Staff Report

Case No. DEXCP 2026-0003

Design Exception for Design Standards for Commercial Construction at
115 Northshore Blvd

FUNCTIONAL DEPENDENT DESIGN

Figure 3. Site and Architectural Plans (following pages)

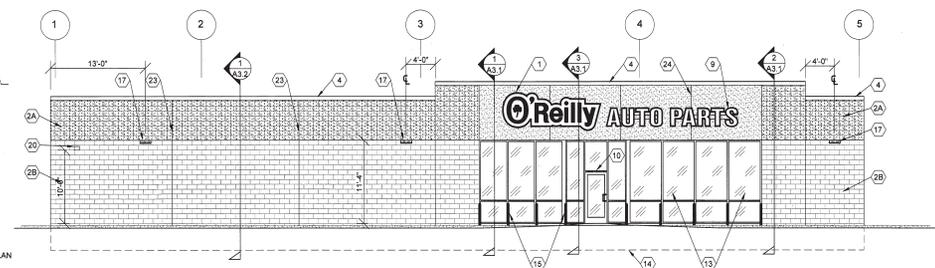
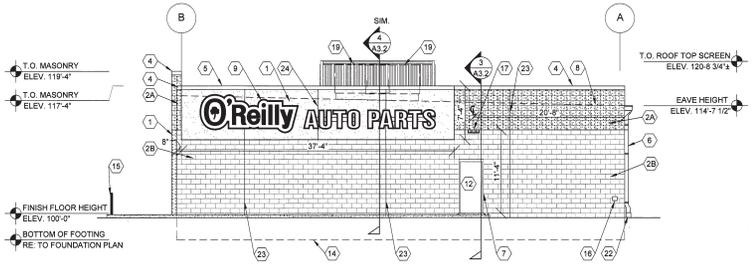
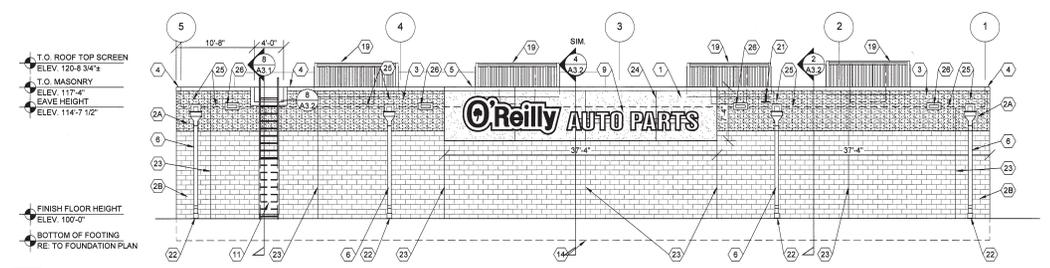
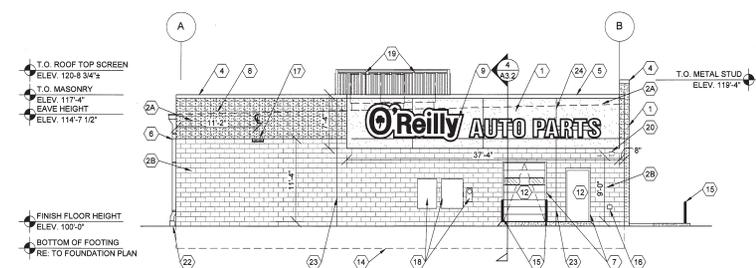
9. Due to the simplified architectural style of the building using clean lines and limited detailing, significant storage area requirements, security provisions, limited area available due to parking accessibility for adjacent sites, required customer access walkway, and the provision of site landscaping, ensuring full compliance with Chapter 8 Section 8.5.7.A. is not supportive of the facility purpose or architectural design and would negatively impact accessibility and landscape compliance. The front elevation does provide one detail in providing architectural relief through an 8" offset of the customer entry portal giving the impression of a recessed entry. (**Figure 3**)

10. Due to the simplified architectural style of the building, significant storage area requirements, security provisions, limited area available due to parking accessibility for adjacent sites, required customer access walkway, and the provision of site landscaping, ensuring full compliance with Chapter 8 Section 8.5.7.C.2. is not supportive of the facility purpose or architectural design and would negatively impact accessibility and landscape compliance. The west elevation does provide visual relief with exposed downspouts creating a limited shadow pattern. (**Figure 3**)

11. Ensuring full compliance with Chapter 8 Section 8.5.7.D. is not supportive of the facility purpose or simplified architectural design; the required transparency is inconsistent with the operational requirements of the building. The design does provide a front façade with 34.7% transparency. (**Figure 3**)

12. Ensuring full compliance with Chapter 8 Section 8.5.7.F. is not supportive of the facility purpose or simplified architectural design; the design does provide for two out of the three required architectural features. (**Figure 3**)

13. The offset for limited façade treatments is the provision of required landscape elements that will effectively screen significant portions of the building façade. Since the applicant and owner understand that per UDC Chapter 8 Section 8.4.3.E.3.e. that "Landscaping must be maintained to ensure continued use of a space for its intended purpose and to ensure continuity of zoning compliance", the overall effect of the landscape is a long-term benefit and is believed to outweigh the functional design limitations. (**Figure 3**)

The Planning Director, after reviewing the proposed construction plans, finds the request complete and has found the proposed design is a functionally dependent design that, while not unique, does have specific visibility, security, and interior space requirements as a retail facility that will need to be reflected in the construction as requested; the provision of screening landscape elements provides visual relief on the redeveloped site.
